City of Portland

*Staff Presentation to the
Portland Design Commission*

**Type III Design Review with
Modifications and Adjustment request**

LU 14-176986 DZM AD

Equitable Access

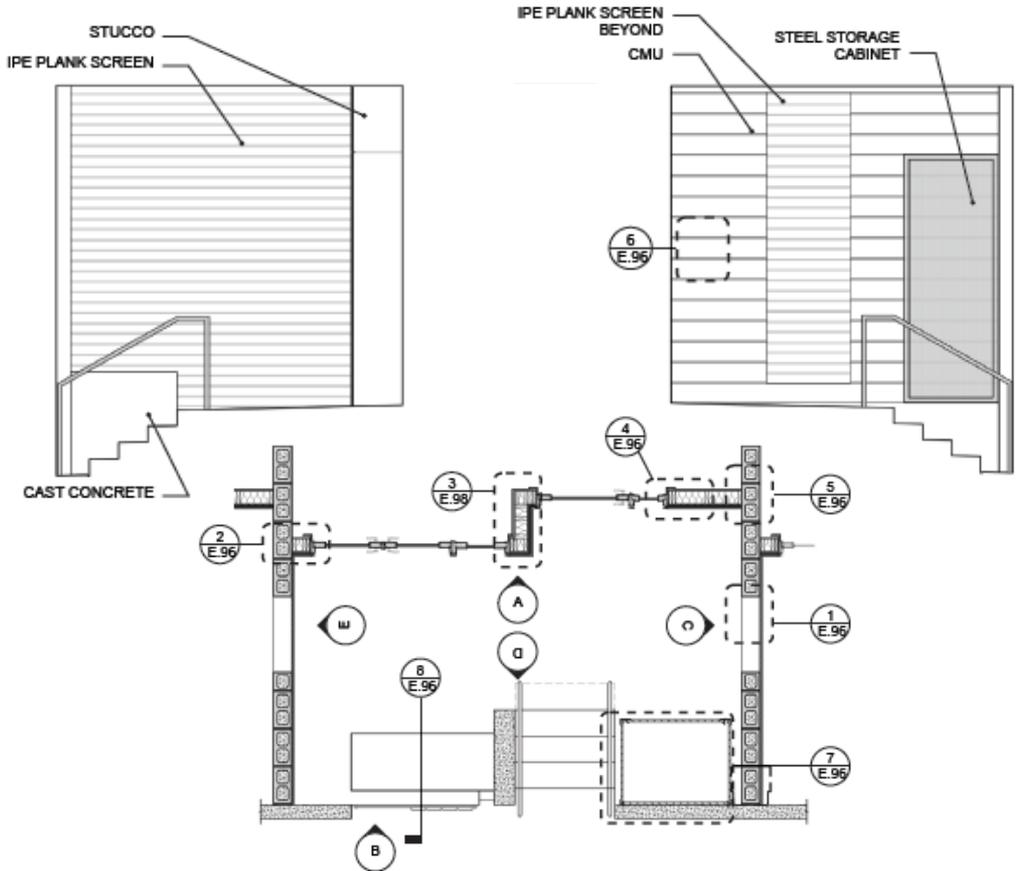
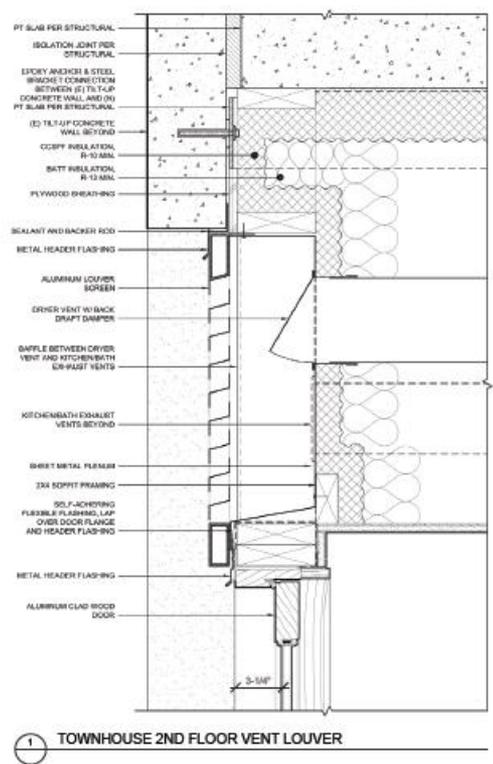
2. Equitable Access at Quimby Plaza

Modification - Setbacks

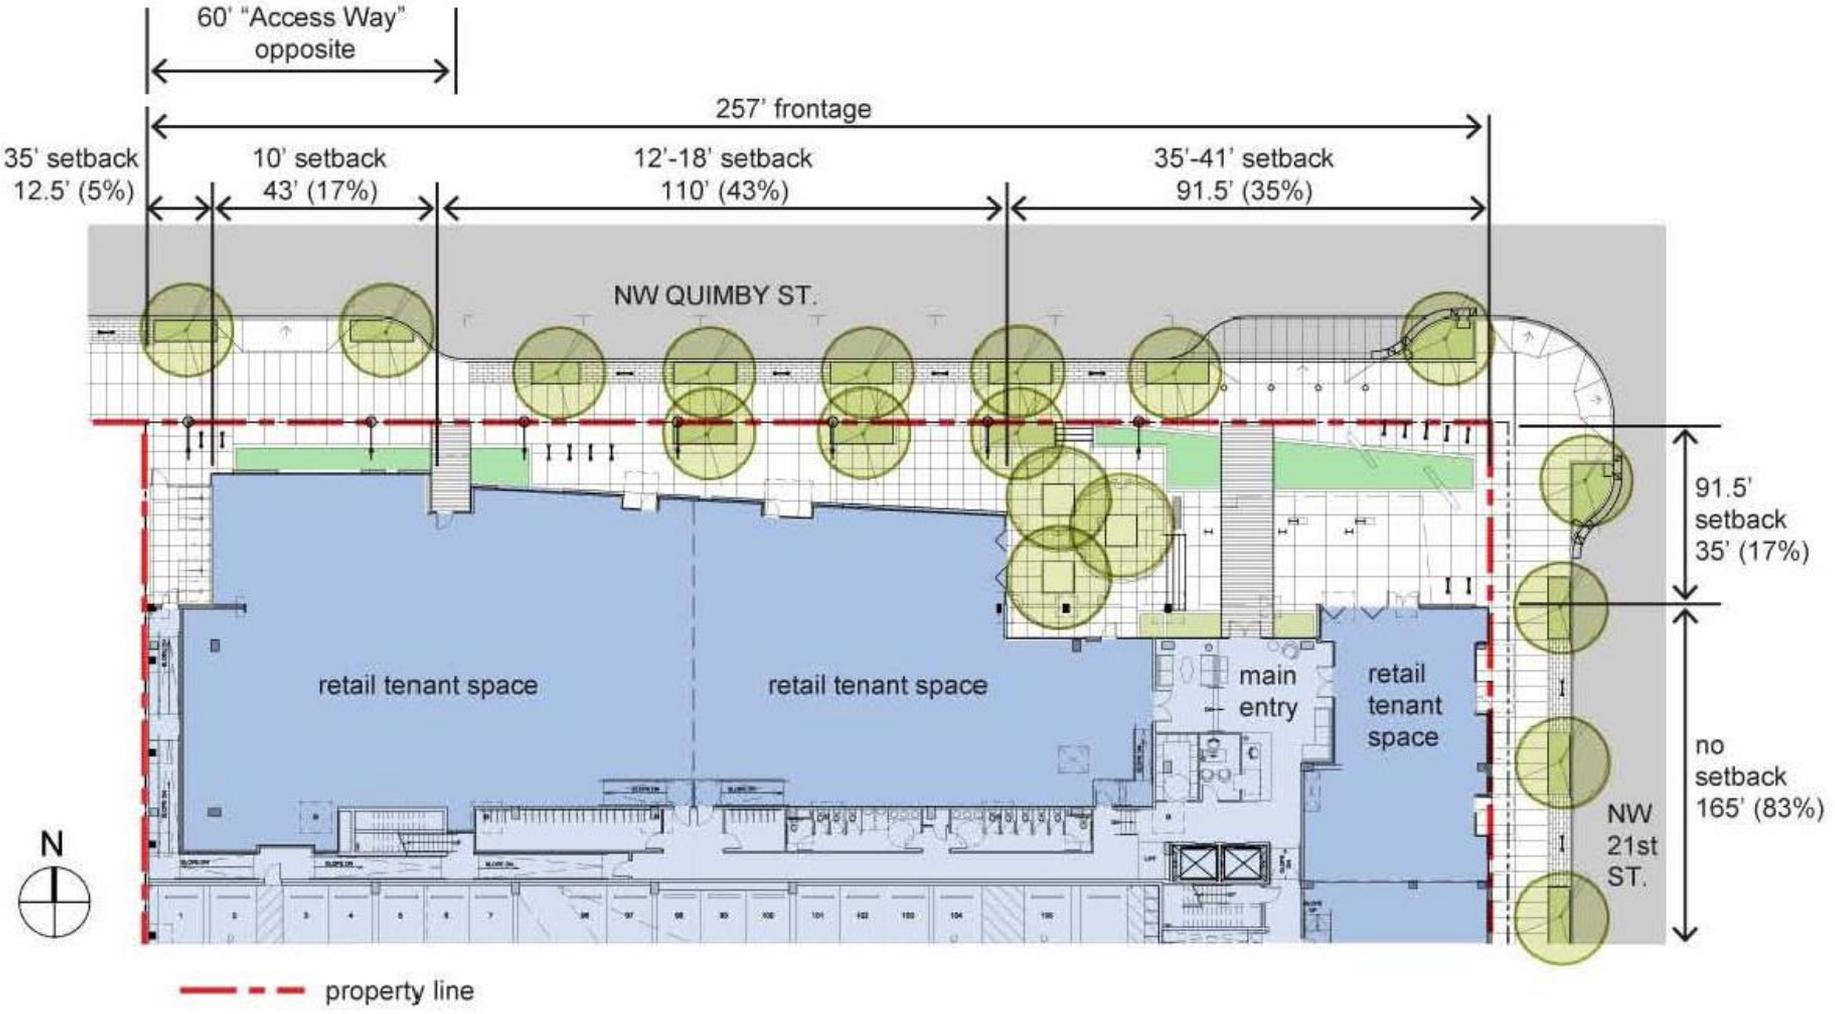
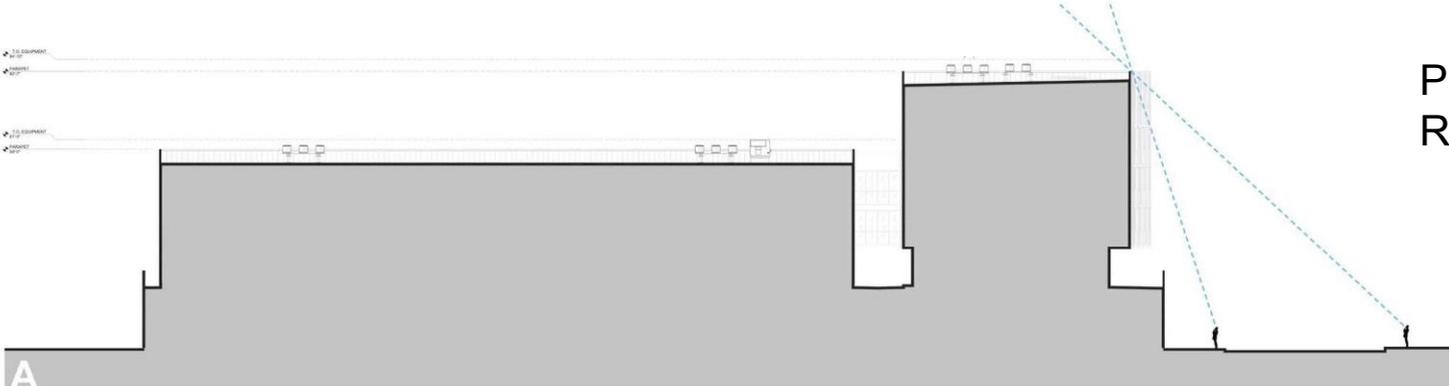
- Reduce 50% maximum 10' setback requirement along NW Quimby to 17% and reduce 100% maximum 10' setback requirement along NW 21st to 83%;
- Increase maximum height from 75' to ~79';
- Reduce required ground floor windows length from 50% to 20.8% and area from 25% to 18.5% on Pettygrove; and
- Reduce size of loading space from Standard A to Standard B

Modification - Height

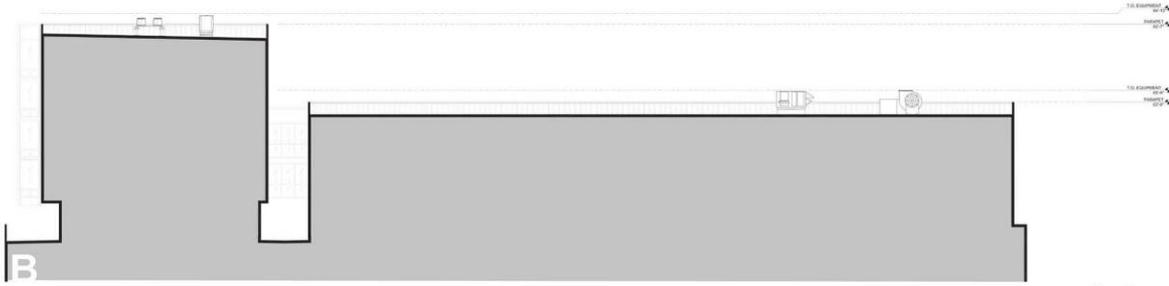
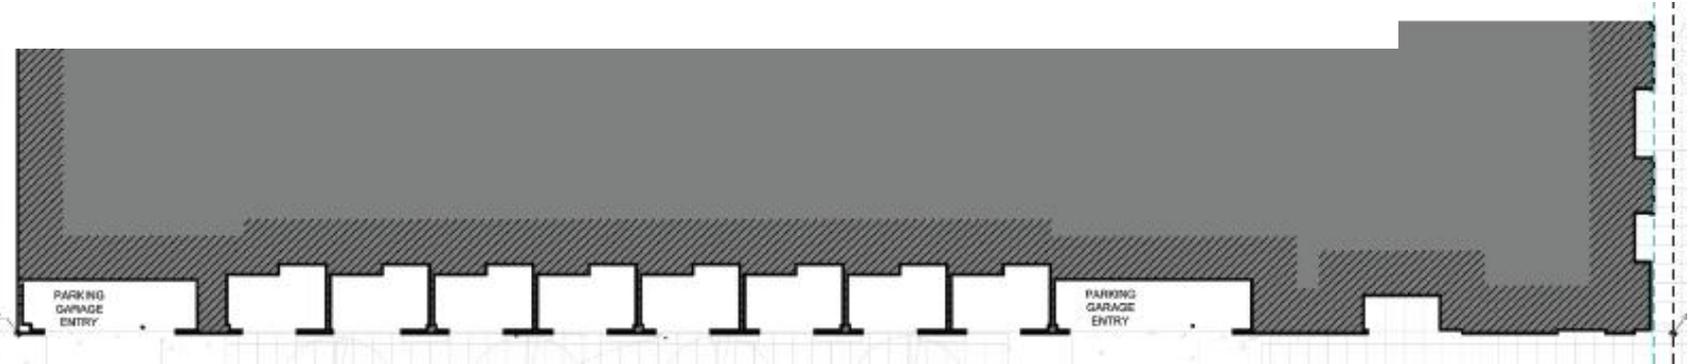
Roofing material will be black EPDM membrane. All mechanical equipment will be painted black to match. Most equipment and vents will be shorter than the parapet.

NW PETTYGROVE ELEVATION

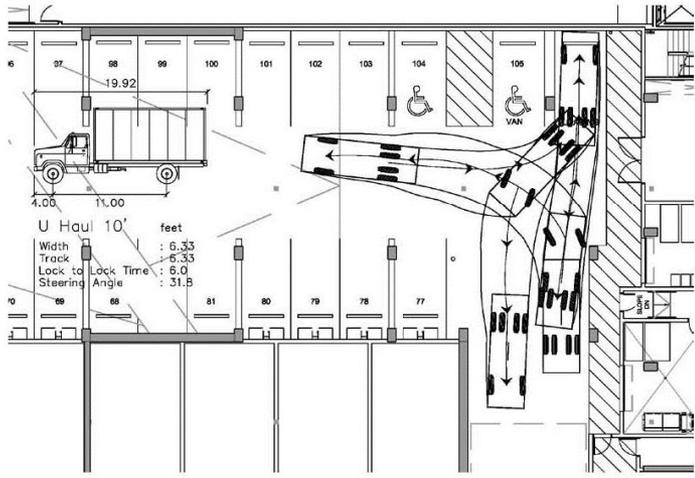
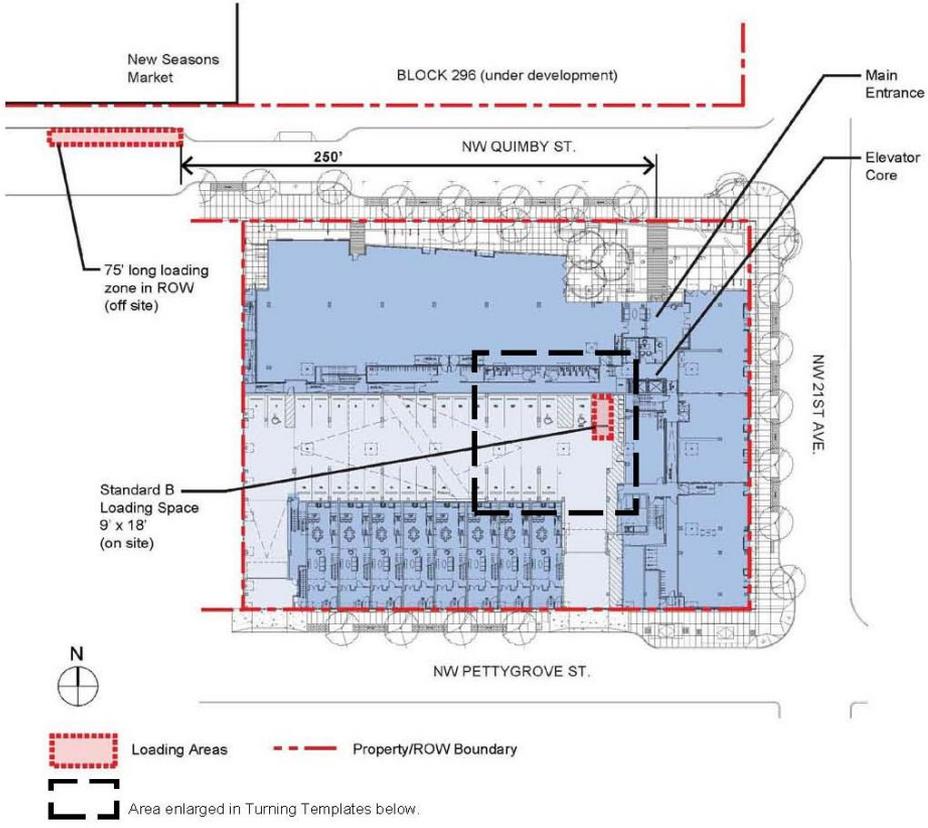
1. Length of Pettygrove Façade

Two separate garage entries and depth of garage access gate

** Pettygrove requires Modification to ground floor windows standards*

Adjustment

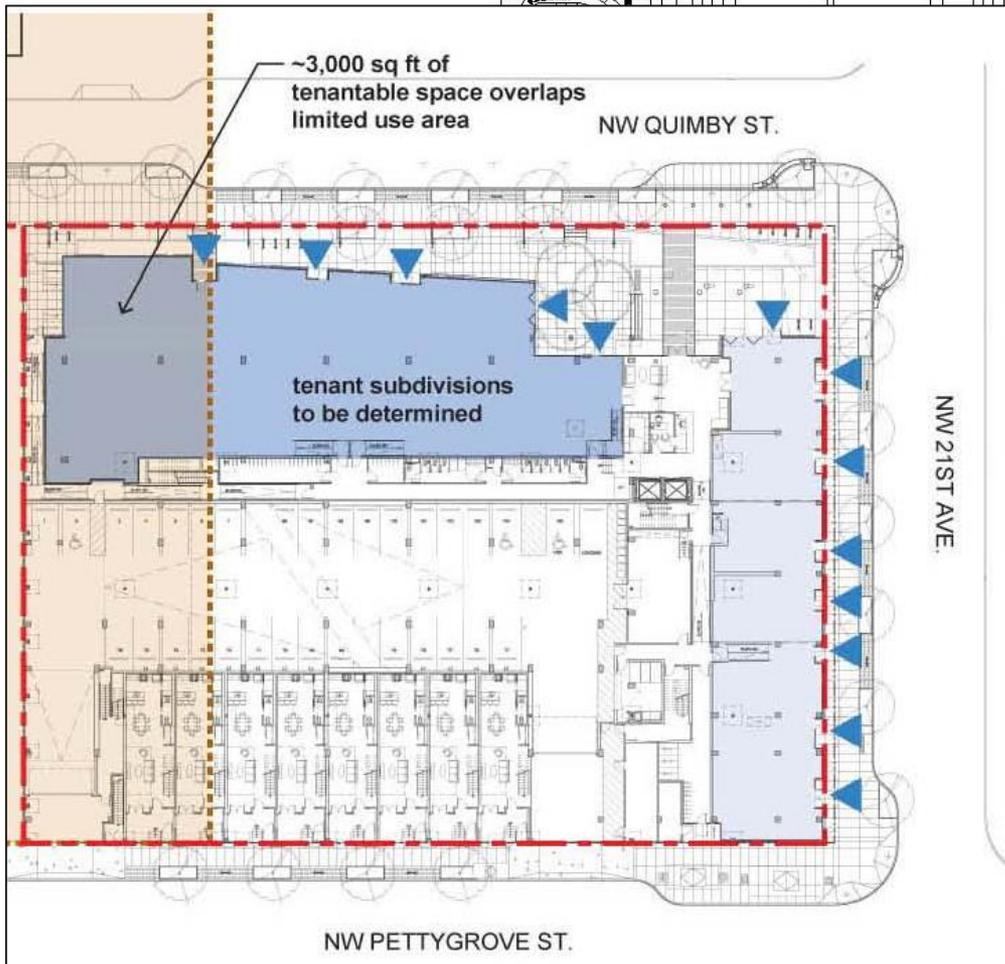
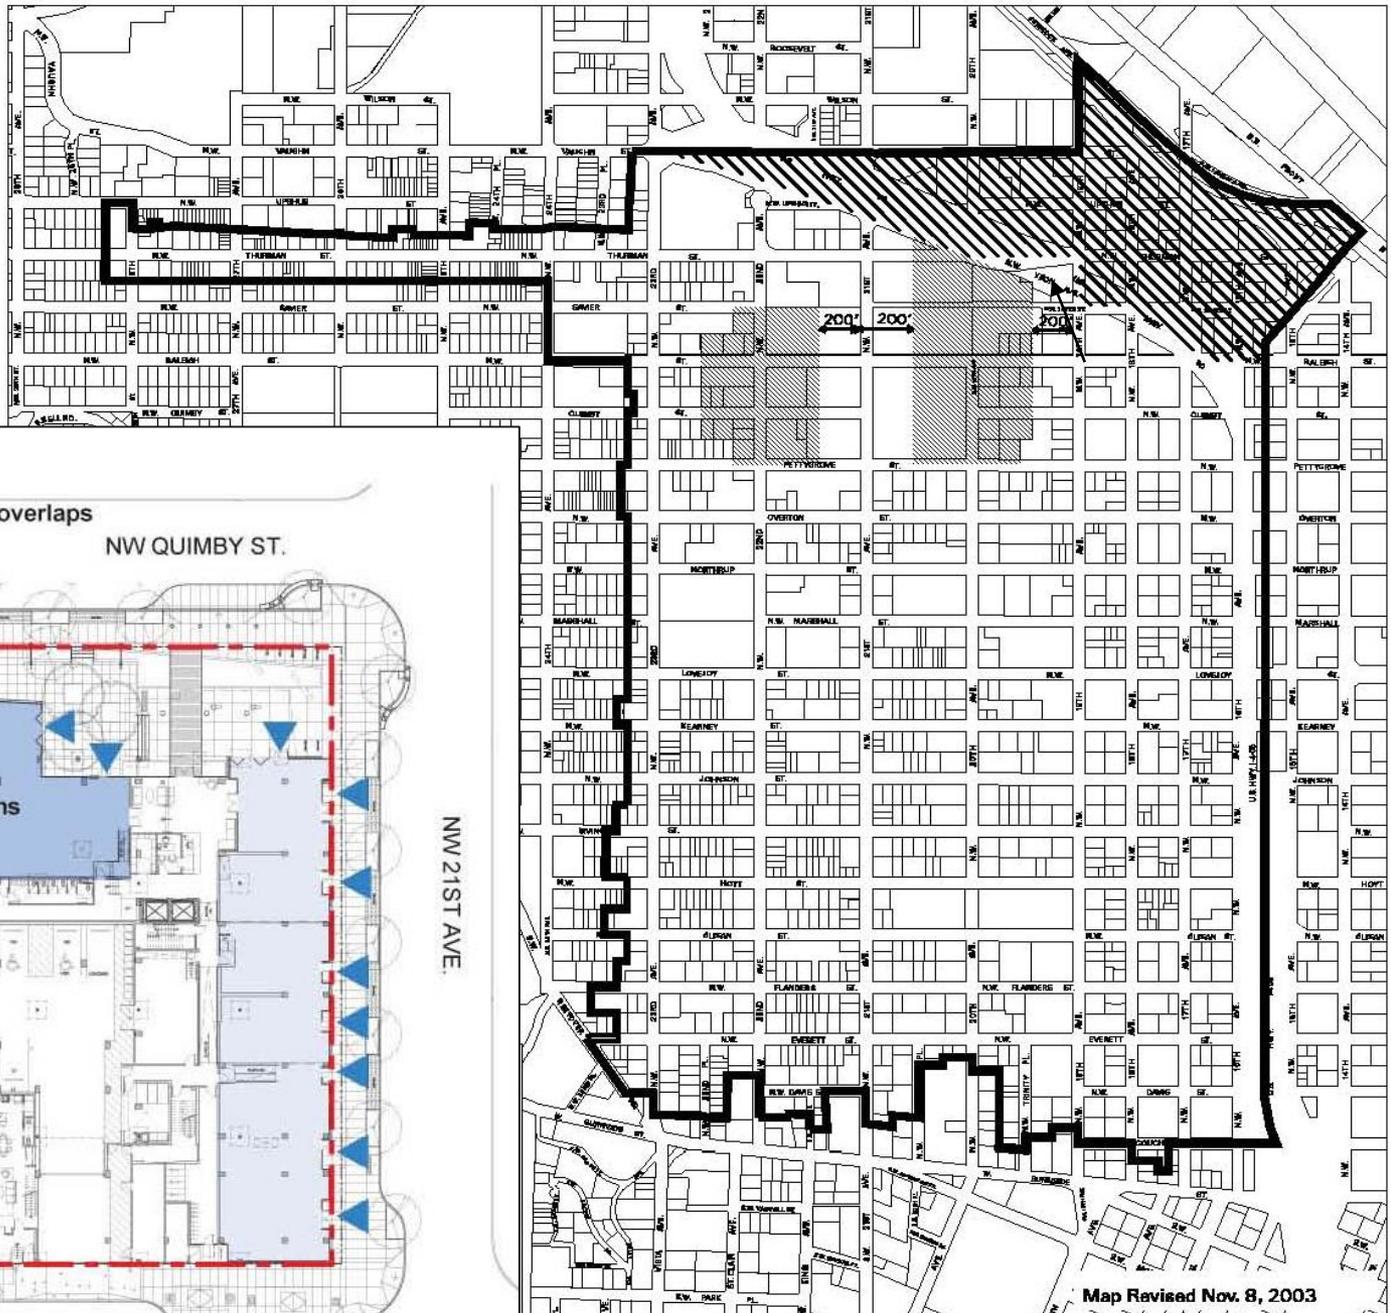
4. Adjustment to Maximum Retail Use Limitation

Retail space along western edge shown to be a maximum of 10,680 sf;

3,000 sf allowed
